Report to the Austrian Government on
Paks NPP Lifetime Extension
Environmental Impact Assessment

Revised Version – Vienna, June 2006

Fig. 1: Various types of margins for a nuclear power plant [IAEA 2004]

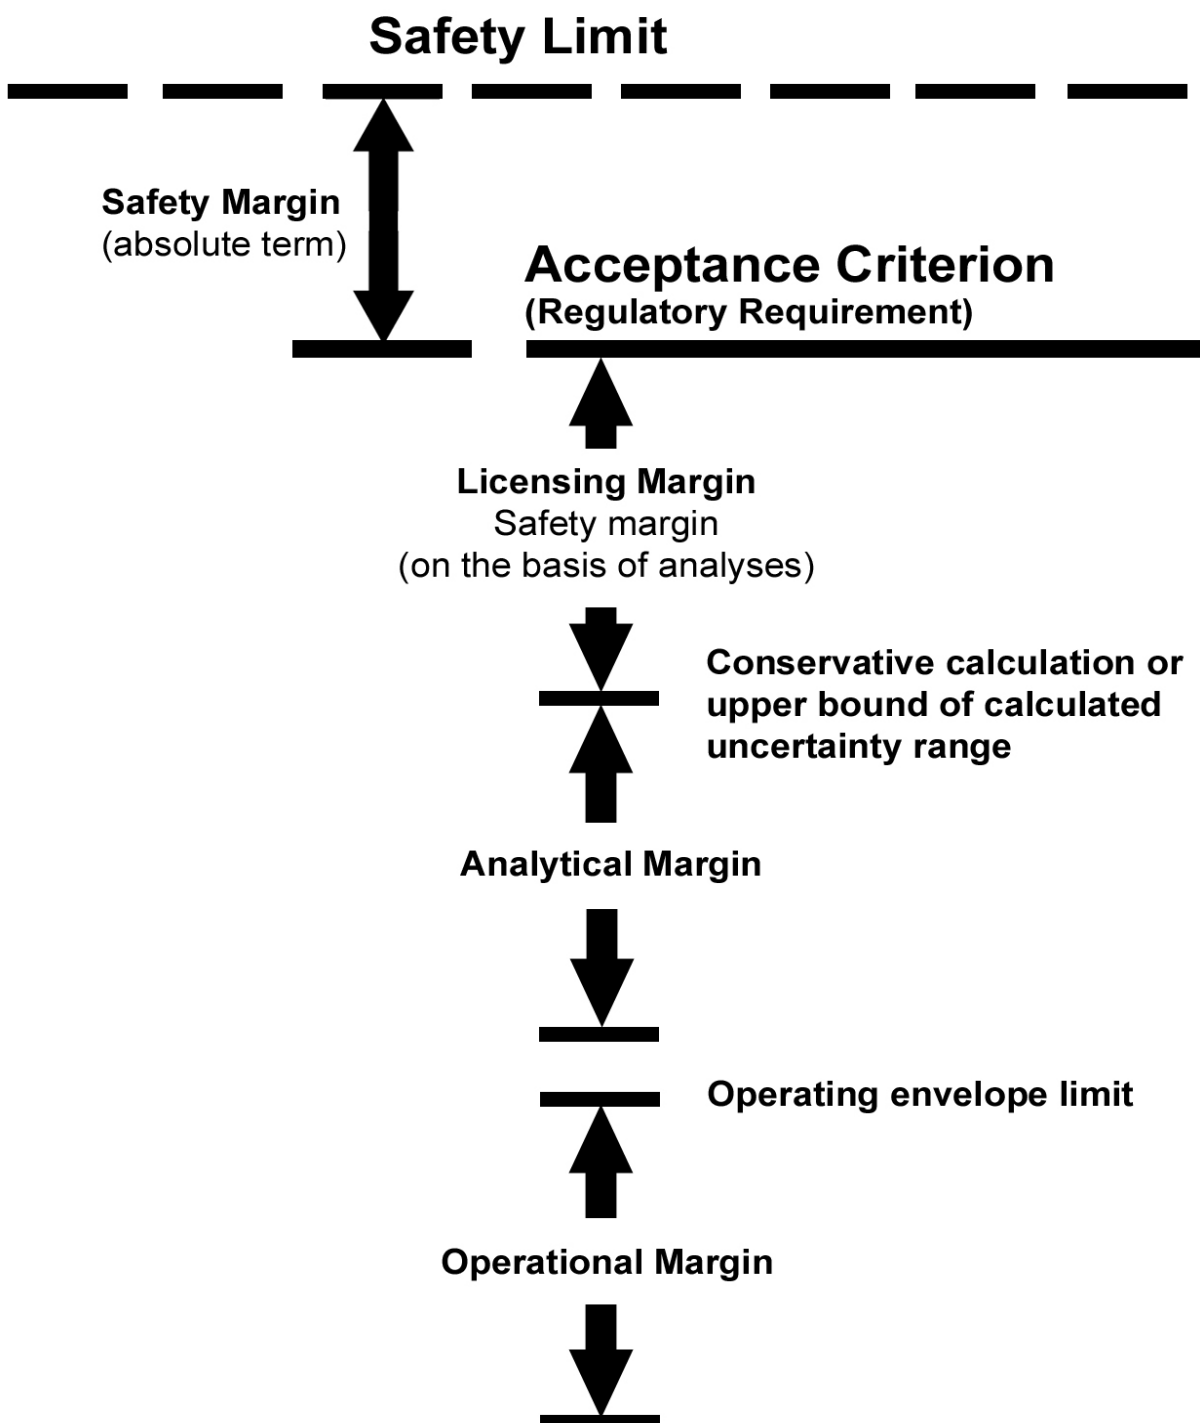
Another source states that “[t]he planned power uprate should not assume significant reduction of any safety margin” [ELTER 2004].

These statements are somewhat contradictory, or they might indicate that different terminology is used in the sources quoted and that the Answers refer to the safety margin in the strict sense of the term, whereas the EIS and the other source refer to margins relevant for safety in general. This point requires clarification, both regarding the apparent contradiction and detailed information on which margins are reduced to which extent.
